Access Compliance Report

Public Rights-of-Way

(Curb Ramps)

Intersection ID: 21548	Main Street: OLD_PROVIDENCE_RD	Cross Street: PROVIDENCE_RD	Location: SW
ADA ID: ADCFBE5FF366	Ramp Type: Perp	Initial Pass/Fail: Fail	Overall Compliance: No
Codes/Mitigation Info/Possible Solution		Field Measurements/Component Compliance	
Severity Score: 13.75

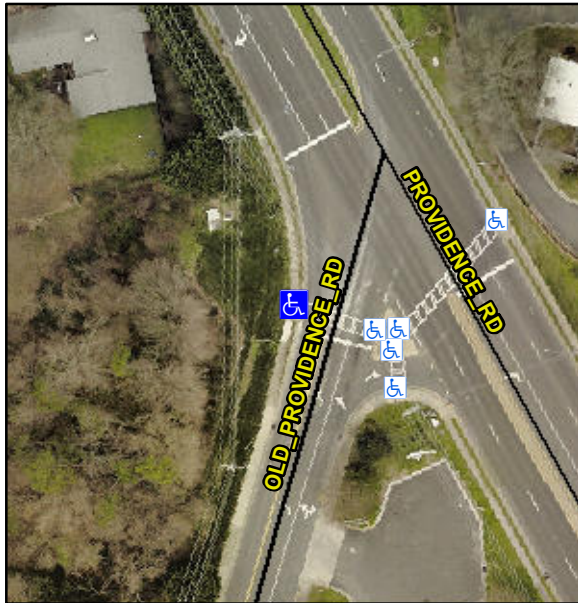
Not Found, R304.2.2, R304.5.3

Compliance	Description	Data	Compliance	Description	Data
N/A	Ramp Length (in)	71.0	No	Ramp Slope (%)	8.6
Yes	Ramp Width (in)	51.0	No	Ramp XSlope (%)	3.5
N/A	Flare Type LT	N/A	N/A	Flare Type RT	N/A
N/A	Flare Slope LT (%)	N/A	N/A	Flare Slope RT (%)	N/A
N/A	Flare Traversable LT?	N/A	N/A	Flare Traversable RT?	N/A
N/A	Landing Length (in)	N/A	N/A	DWS Provided?	N/A
N/A	Landing Width (in)	N/A	N/A	DWS Contrast?	N/A
N/A	Landing Slope (%)	N/A	N/A	DWS Length (in)	N/A
N/A	Landing X Slope (%)	N/A	N/A	DWS Full Width?	N/A
N/A	Landing Curb? (Y/N)	N/A	N/A	DWS Offset (in)	N/A
N/A	Shared Landing?	N/A			
N/A	Gutter Ponding?	N/A	N/A	Gutter Slope (%)	N/A
N/A	Gutter Lip Ht (in)	N/A	N/A	Gutter X Slope (%)	N/A
N/A	Painted X Walk1?	Yes	N/A	Painted X Walk2?	N/A
	X Walk 1 Direction	To SE		X Walk 2 Direction	N/A
N/A	X Walk 1 Width (in)	74.0	N/A	X Walk 2 Width (in)	N/A
	X Walk 1 Slope (%)	2.0		X Walk 2 Slope (%)	N/A
	X Walk 1 X Slope (%)	2.2		X Walk 2 X Slope (%)	N/A

N/A	Ramp inside XWalk1?	Yes	N/A	Ramp inside XWalk2?	N/A
	Road Slope (%)	N/A	N/A	Clear Space?	N/A
	Road X Slope (%)	N/A	N/A	Clear Space to XWalk (in)	N/A
N/A	Any Obstructions?	N/A	N/A	Storm Grate/Utility Hazard?	N/A
	Obstruction Type			Storm Grate/Utility Type	
		N/A			N/A
			Yes	Surface Condition? (G/P)	Good

Remove & Replace Entire Ramp.
